Loosening of COBRA Handle Manifold – JFD Guidance Note

COBRA Bailout System

COBRA Guidance Note

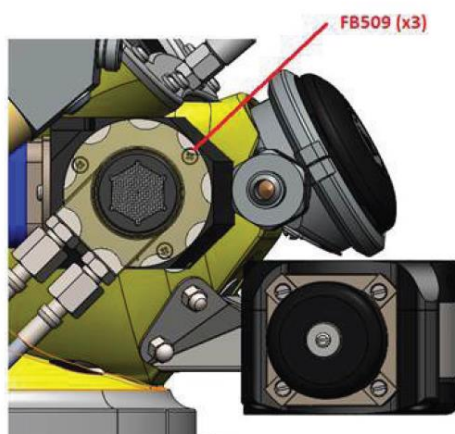
JFD have had reports of the Handle Manifold becoming loose within the Activation Assembly on the Helmet

After repeated use, the M3 countersunk screws (pt. no. FB509) used to secure the Handle Manifold can loosen and occasionally unscrew completely, leaving the Handle Manifold insufficiently secured into the Mouthpiece Housing on the helmet.

The general torque stated in the COBRA manual for an M3 screw in a Tappex insert is insufficient in this location. These 3 screws (pt. no. FB509) should be tightened to 8 inch-pounds. Additionally, Loctite 222 should be applied to the countersink area of the screw only. It is important that the Loctite is not applied to the thread of the screw, as this may cause slackening of the insert when the screw is removed.

It can also be advantageous to remove the Activation Handle to allow improved access to these screws.

The torque of 3 inch-pounds for M3 screws remains appropriate for other locations on the COBRA set.
